**HISTORIC PRESERVATION BOARD STAFF REPORT**

<b>46 Marine Way</b>		
<b>Meeting</b>	<b>File No.</b>	<b>Application Type</b>
July 1, 2026	HP-544-2026	Certificate of Appropriateness, Demolition, Relocation, Variances, & Waivers

The item before the Board for consideration of a Certificate of Appropriateness (HP-544-2026), Demolition, Relocation, Variances, & Waivers in association with the vertical relocation, alteration and additions to the existing main contributing structure and demolition of the accessory contributing structure for the property located at **46 Marine Way, Marina Historic District**.

**Proposed Addition – 6/3/26**

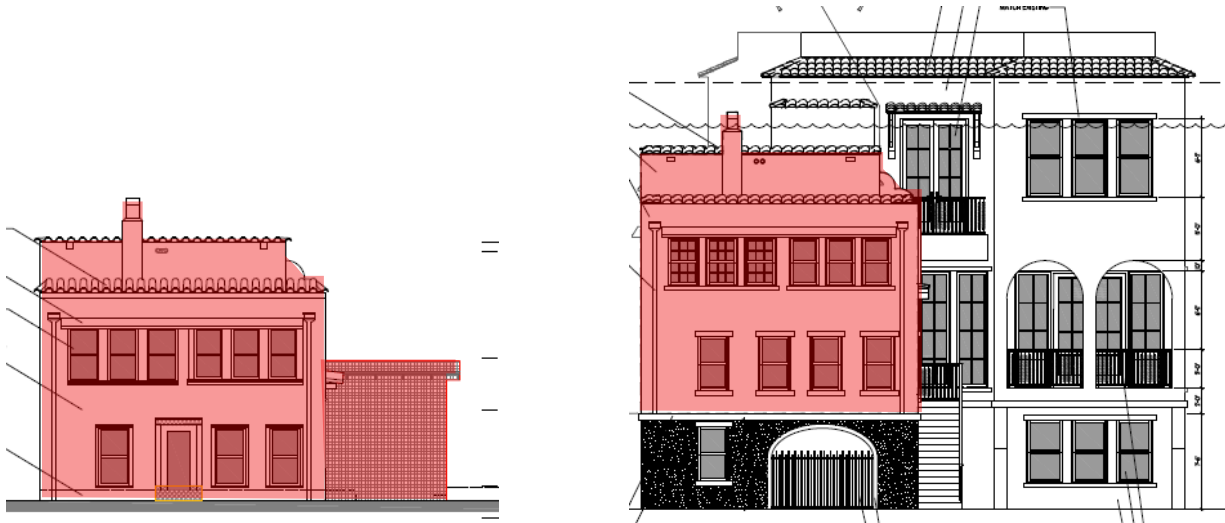
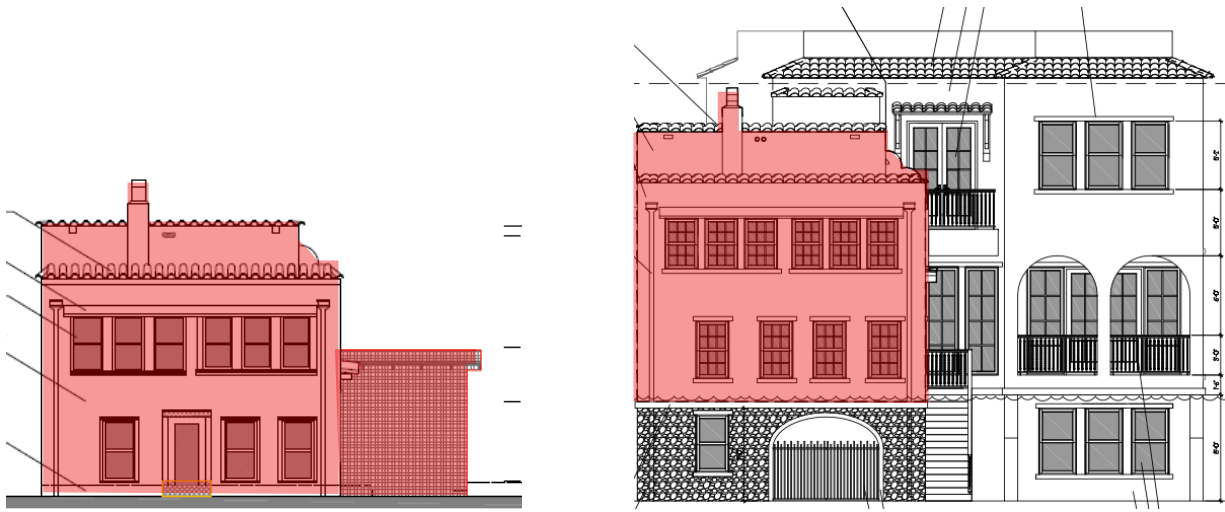
With regard to **Standards 9 and 10**, there is concern with the proposed size of the rear addition, however, the proposal has been revised to reduce its overall size. The previous proposal was for two stories, as is the existing structure, but the interior ceiling heights were substantially taller than the historic structure. As previously proposed, the existing contributing structure was to have a new height

of 19 feet 7 inches (measured from the new finished floor elevation which is approximately 7 feet 6 inches to 9 feet 4 inches above existing) and the addition would be at 26 feet (nearly a story taller than the existing structure, a 6 feet 5 inch difference). The revised proposal requests retains the elevation of the existing structure 10 feet and 11 feet 10 inches, with the revised addition at 24 feet, an overall 2 feet reduction in height. This reduction is leaning more towards compliance. The revision does not proposed a reduction to the width, where it remains substantially wider than the existing main structure, however, it is still recessed 24 feet behind the front wall plane; entirely behind the existing main structure. Thus, the waiver for the Secondary and Subordinate Visual Compatibility standard continues to be requested and is analyzed later in the report. The revision continues to utilize a series of methods/designs on the addition that allow it to be architecturally compatible but differentiated from the historic structure. The larger size of the openings on the addition (to accommodate the larger ceilings heights), the introduction of arched features for the garage entrance and balconies, and utilization of a different coral feature along the walls of the carport are some ways the new structure has been integrated into the architecture. Overall, these differences ensure a degree of compatibility, in an attempt to not overwhelm the main residence. Yet, some concern remains with some of the elevations and architectural detailing that is discussed within the Visual Compatibility standards section.

structure, affecting visual compatibility relating to additions being “as inconspicuous as possible”. The addition being recessed, the open-air balconies, and the introduction of a carport does aid in reducing the intensity of the proposed modification. It is understood that the structure must be elevated for not only FEMA/Florida Building Code requirements, but for the preservation of the structure. Efforts should be made to keep the existing structure as the focal point of the site, when accommodating new additions, which the revised proposal has made some additional modification to maintain the existing structure as prominent. This includes the six-over-six windows along the front of the existing structure, providing differentiation from the new, and the organic raised coral material beneath, which was previously blending in with the existing structure. Two waivers for relief have been submitted to the Building Height Plane and Additions (Secondary and Subordinate) visual compatibility standards. Both are analyzed later in the report.

**Proposed Building Height Plane - 6/3/26**

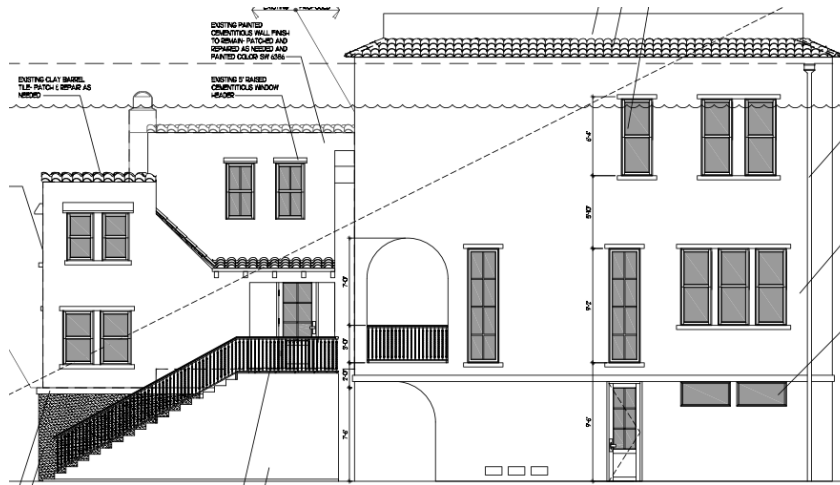
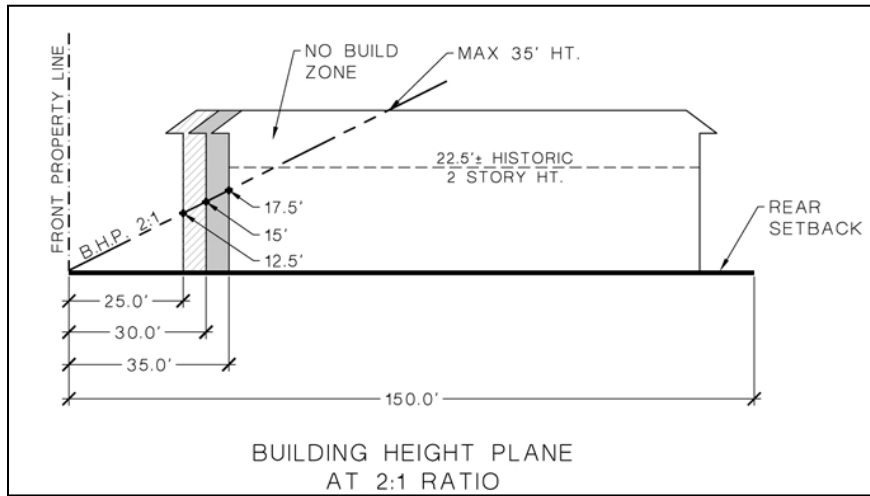
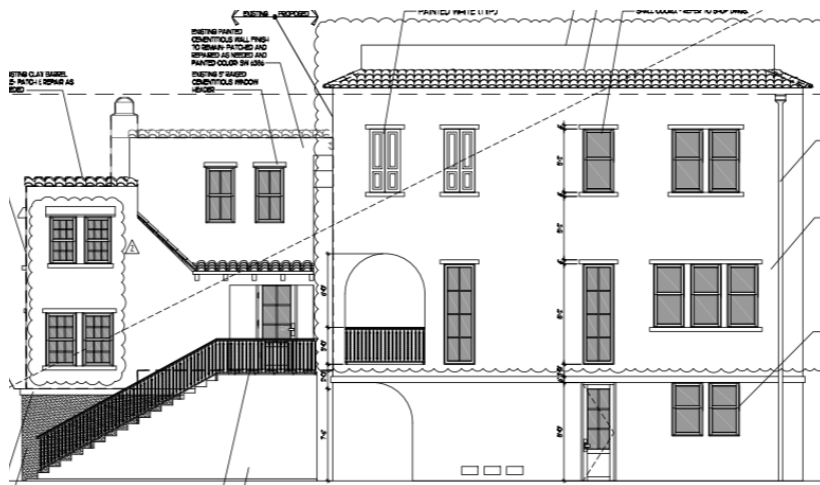
The Waiver request is to allow the existing vertically elevated structure and portions of the two-story addition to encroach within the required 2:1 Building Height Plane (BHP) ratio.

The request would allow for the existing two-story structure, once elevated, and portions of the proposed two-story structure to encroach into the “No Build Zone” of the BHP standard requirements. The revised proposal reduces the overall height by 2 feet, however, there is still concern that relief will cause the overall request not to be compatible with the historic streetscape as this standard is a tool to control massing and height within historic districts. It is noted however, that vertical elevation of historic structures along Marine Way is imminent given recent increases from FEMA to the minimum finished floor elevation requirements and ongoing flooding occurring in the area. The concern is to what degree the waiver is necessary. The reduced height does reduce the amount of the addition within the building height plane. Some level of waiver is anticipated with improvement of the property. The board will need to make a determination that the waiver shall not adversely affect the neighboring area.
